**ADDENDUM NO. 3**

**Bob Hart Square Expansion**  
**Project Number CP220073**

The following revisions to the Specifications shall be made:

#### DIMENSION AND PAVING PLAN

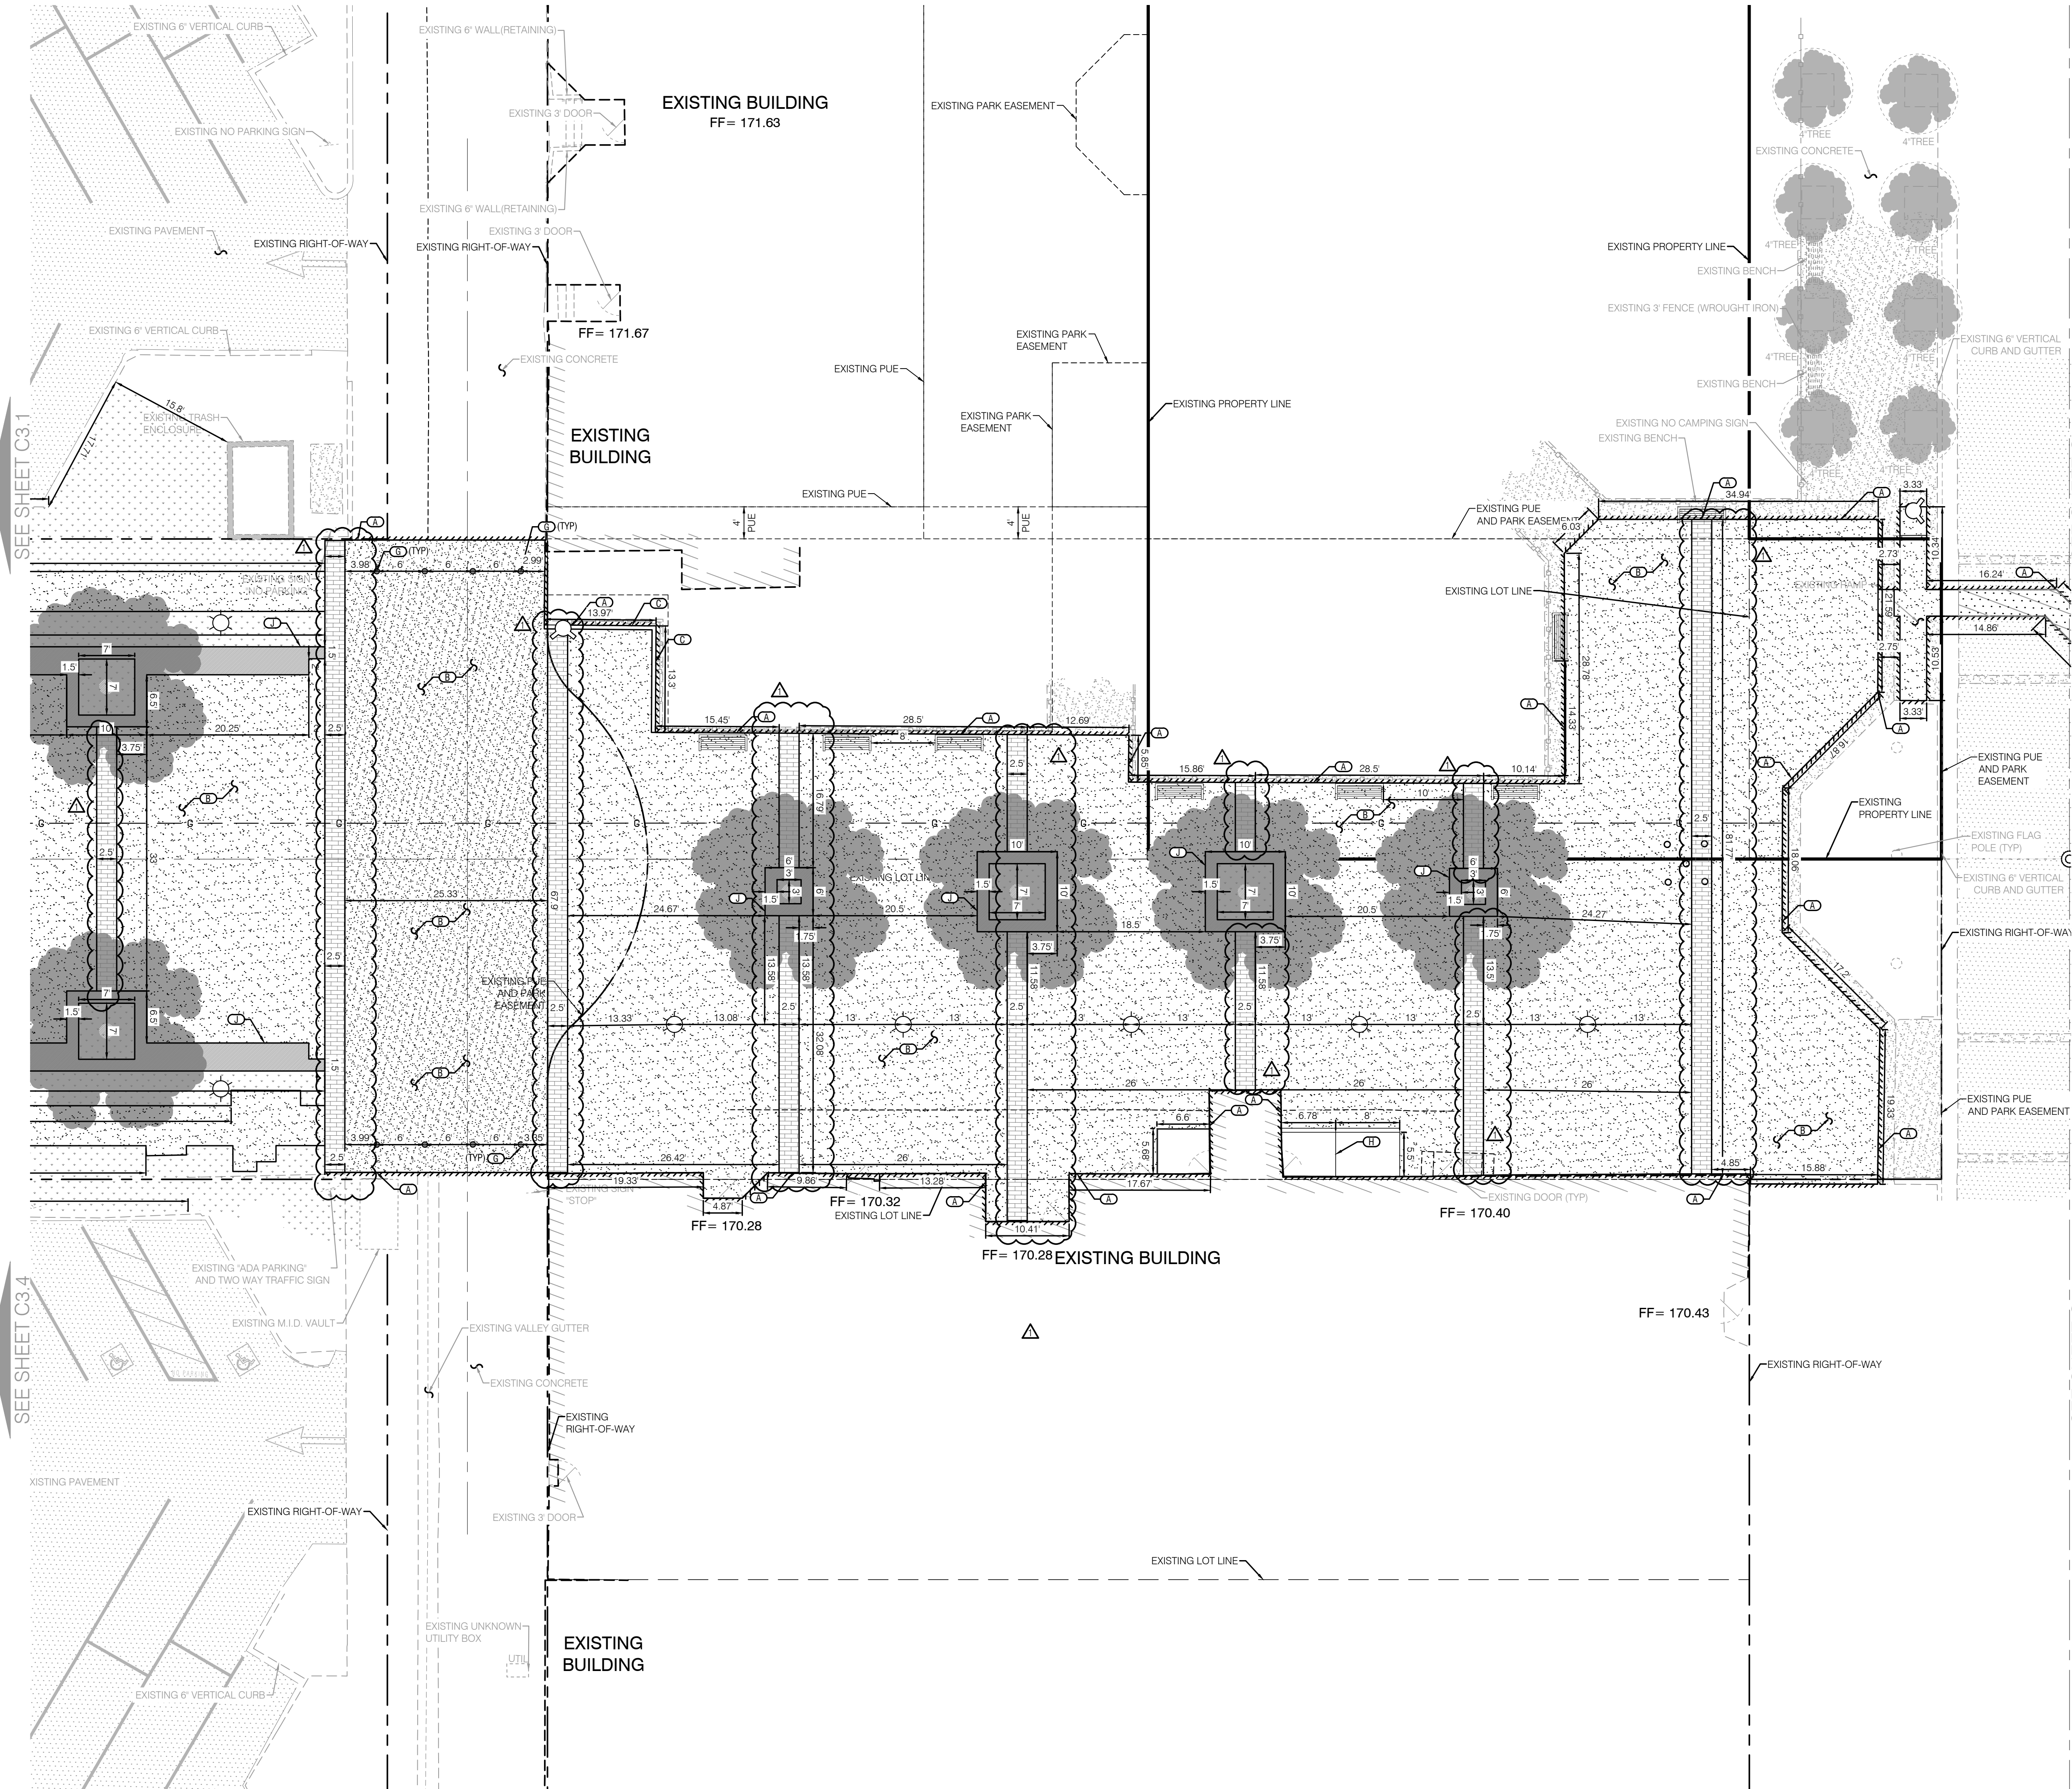
NO.	REVISIONS	DATE	APPROVED
1	ADDENDUM 01: ADDED BRICK BAND SECTIONS	10/16/2024

**1 COMMUNICATIONS INFRASTRUCTURE**  
SCALE: 1/16" = 1'-0"

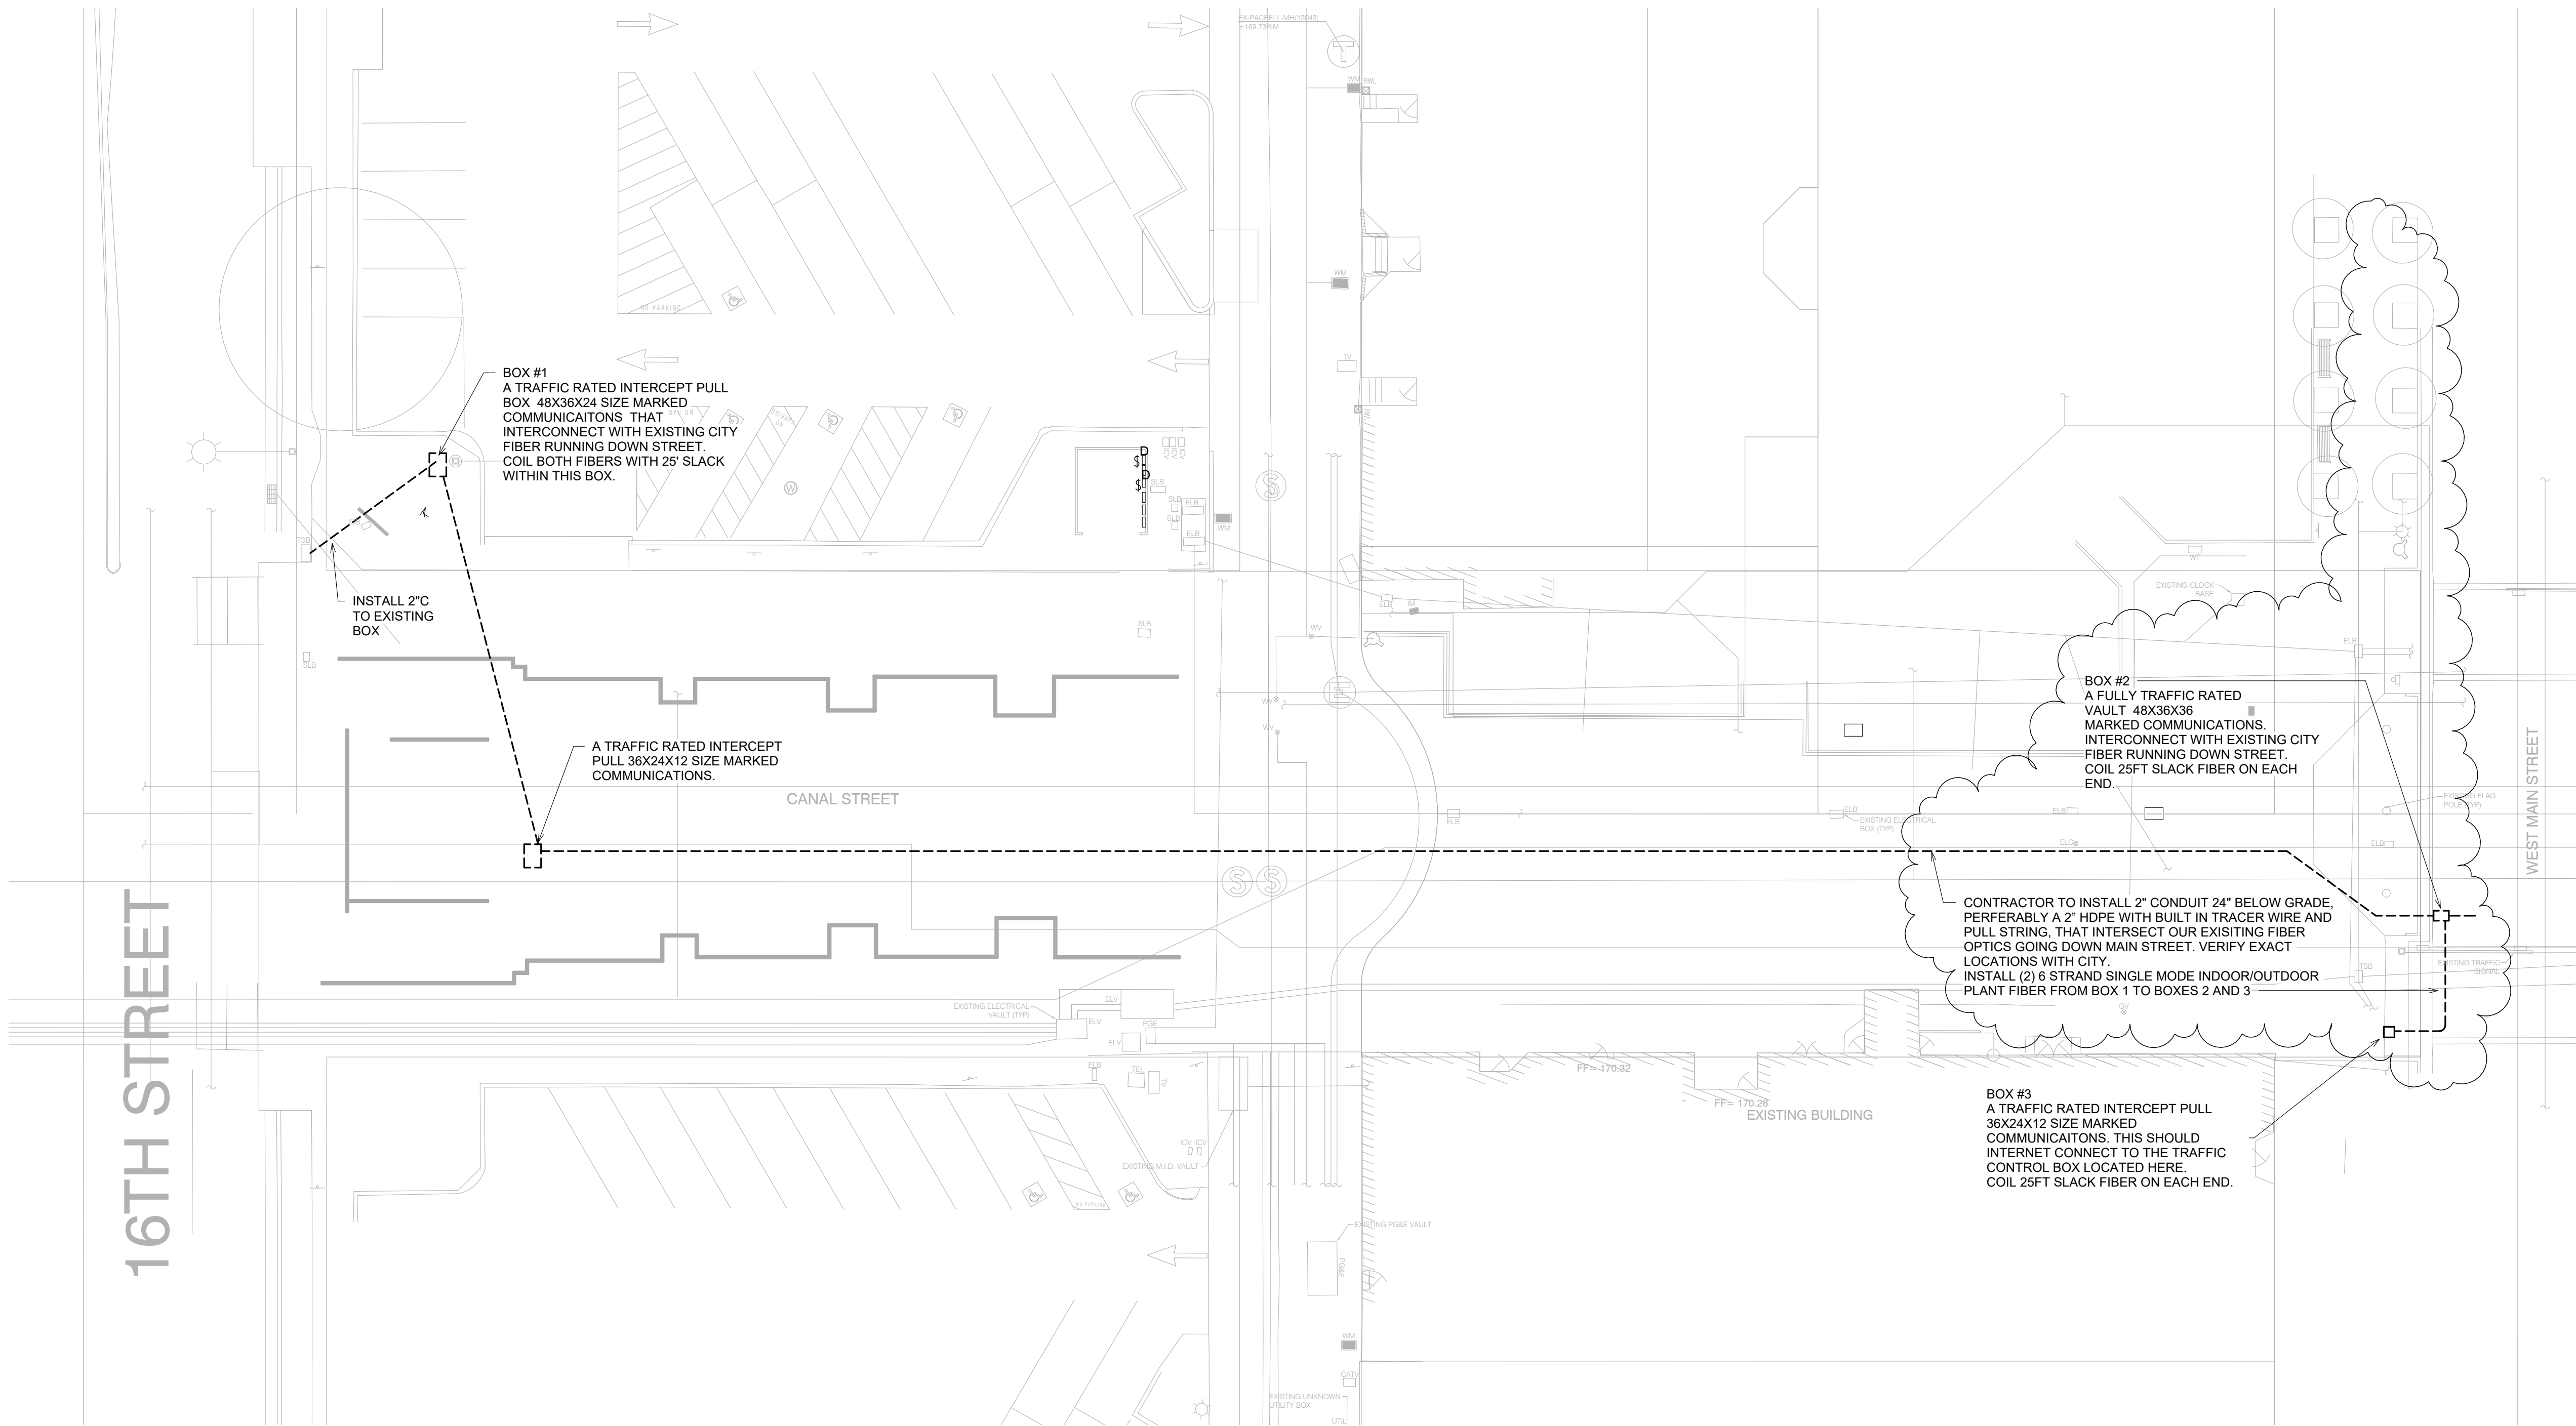
REVISIONS	BY
ADDENDUM 1 10.16.2024	RCS
